UNITED STATES PATENT AND TRADEMARK OFFICE

| APPLICATION NO. | FILING DATE | FIRST NAMED INVENTOR | ATTORNEY DOCKET NO. | CONFIRMATION NO. |
|-----------------|-------------|----------------------|---------------------|------------------|
| 10/674,198 | 09/29/2003 | James Patrick Clinch | 140/40652/O&T 975 | 2676 |

Office Action Summary

DETAILED ACTION

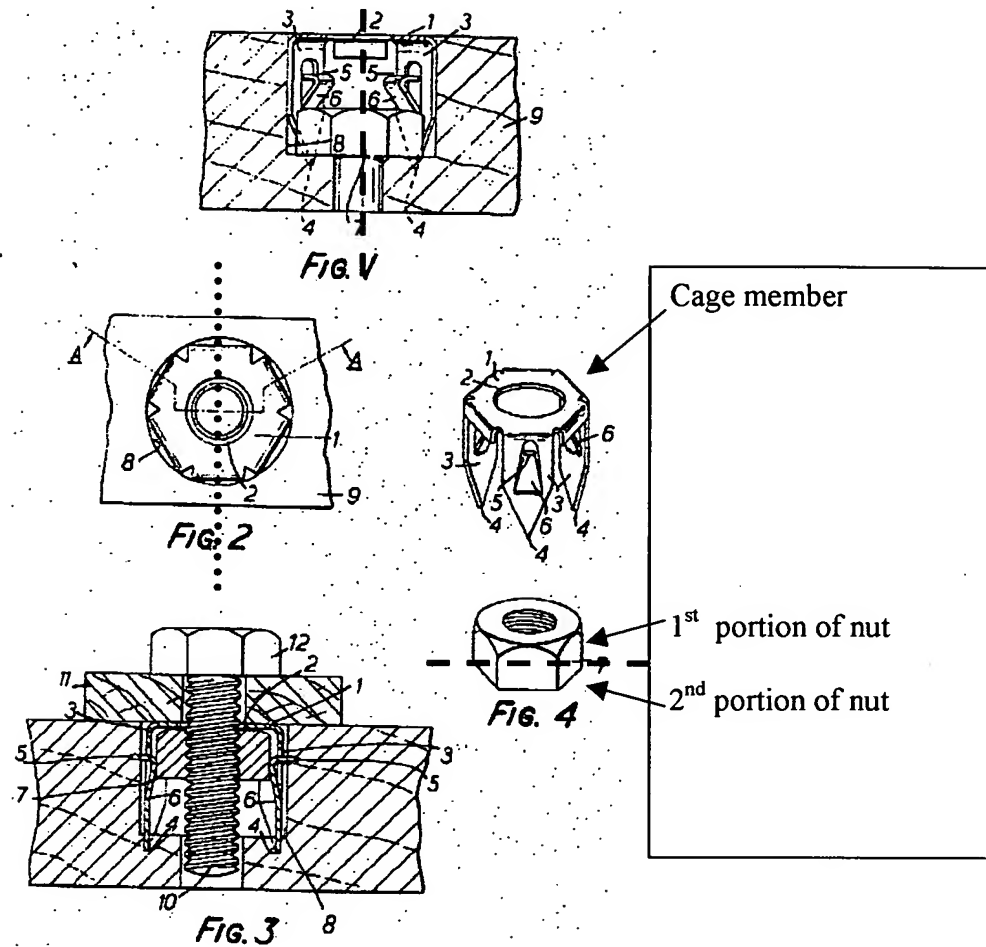
Re claims 1 and 10: Parkin teaches a cage member (upper item in Fig 4) engageable with nut 7 having first and second portions and an aperture extending at least partially therethrough, (note that applicant is not claiming the nut, and a nut is capable of having distinct first and second portions. **However, further regarding claim 10**, the nut of Parkin can be considered to have a 1st portion [upper section in the figures, having the tapered sides] and a 2nd portion [lower section without taper]) thereby providing a cage nut assembly, said cage member comprising:

Said body defining a base portion (1) and at least one wall portion (3) and configured to engage the nut first portion such that the nut second portion does not come into contact with either the base or said at least one wall (Fig 1- notice that neither portion of the nut contacts the base or at least one wall, and in Fig 3, the 2nd portion does not contact the base or a wall 3), said body provides a limited range of nut movement in at least one dimension (axially along what could be called the bolt axis - see dashed line by examiner in Fig 1 above, although there is slight radial movement

Re claims 2-3, 5, 11-12,14: Said upper portion comprises at least one arm (6). Looking at Fig 2, note that there are at least two arm portions (6) which are positioned on opposite sides of a plane that bisects the base (see Fig 2 and examiner-drawn dotted line for plane), thus they are positioned opposite one another. The arms define an opening sized to receive the nut member therethrough when the nut 1st portion is engaged by said 2 arm portions (See Fig 3). Examiner notes that applicant did not require the arm to extend **directly** from said base.

Re claims 6,15: Fig 1 shows each arm 6 with a generally "C" shaped portion, and forming an opening between opposite arms.

Re claims 7,19: Looking at the difference in arm 6 between Fig 1 and Fig 3, it is clear that it is inherently flexible.

Re claims 8,20: As best understood, at least one arm portion can be moved (see Fig 1 and 3 comparison of arm for movement) to allow the 2nd portion of the nut member to be positioned above said base (entire nut is always above said base). Nut is between at least one wall portion of said body and something - an opposite wall.

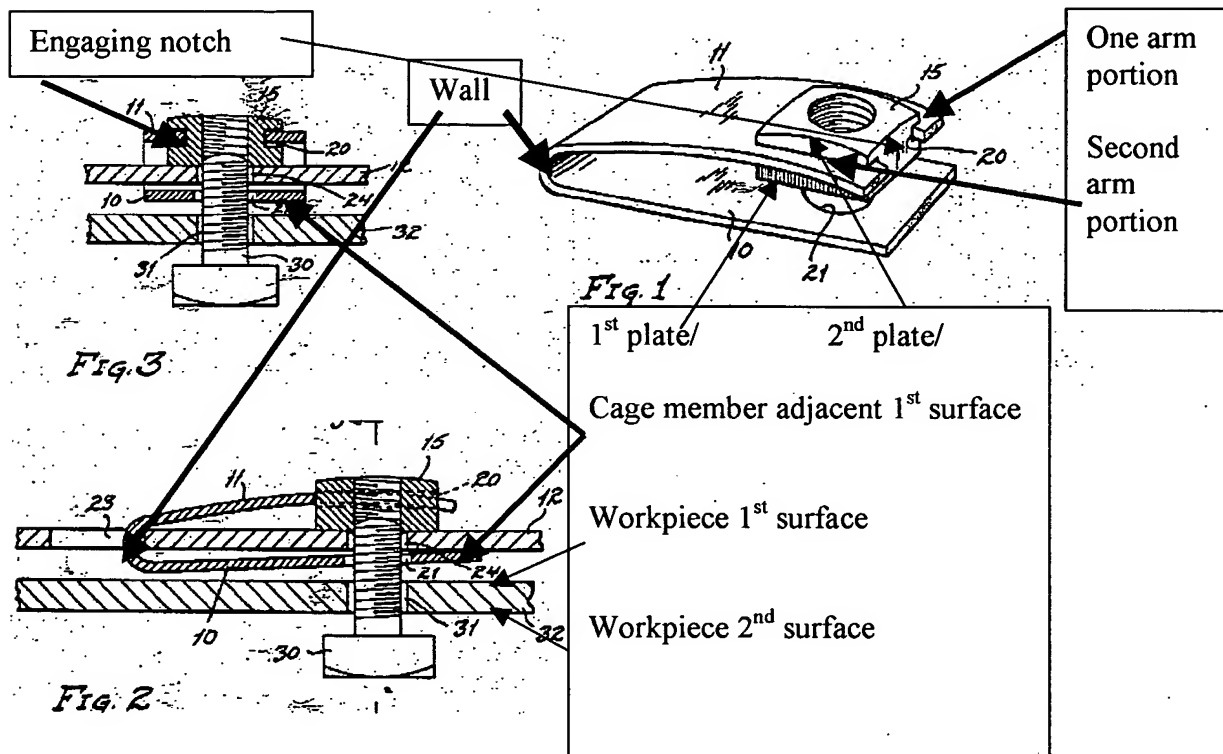
Re claims 1,2,3, 7,8,10,11,12,19,20: Tinnerman 342 in Figs 1-3 teaches a cage member and nut assembly, said nut (15) having a 1st and 2nd portion (see marked up

drawings below) enclosed by a cage member (10/11) which has a body configured to engage the nut member such that the nut member is encaged. The cage further comprises a body (11/10), and "11" is considered the upper cage/arm portion, and "10" is the base. The wall is labeled by examiner in drawings below. The nut engagement is such that the 2nd portion (same as the portion labeled "1st plate" below - looking at the drawings as oriented, it is the "lower" part of nut below "11") of the nut does not come into contact with either the base or the wall. Figs 1 and 3 shows a limited range of motion in at least one dimension. The body provides a limited range of nut movement in at least one dimension (axially along what could be called the bolt axis - although there is slight radial movement also).

Further Re claims 3 and 12: As shown in Fig 1, arm portion 11 forms two arm portions at the end as labeled by examiner in drawings below. These two arms are opposite each other.

Further Re claims 8 and 20: As best understood by examiner, the at least one arm 11 can be moved to allow nut 2nd portion to be positioned over base and between the wall and something - in this case the very end extension of the arm 11 past the notch.

Re claims 22 and 29-30 and 34-35 and 39-42: Tinnerman '342 in Figs. 1-3 teaches a nut (15) enclosed by a cage member (10/11) which has a body configured to engage the nut member such that the nut member is encaged. (Fig 1 and 2) "11" is considered the upper cage portion, and engaging notch (best shown in Fig 1 and 3) will inherently serve to suspend the nut off the base.

Further, the upper portion (arm 11) of said cage member is configured to engage said nut member 15 and is configured to be flexed downwardly by said nut member toward said base portion 10 in order to allow said nut member to contact said base portion (Fig 2). Examiner notes that applicant did not claim direct contact, and it is in contact via contact with intermediate member 12. Fig 2 shows the combination including

Re claim 32,37: The body further comprises at least one wall (see label by examiner above), and Figs 1- 3 show the nut engaged such that the nut does not contact at least one wall.
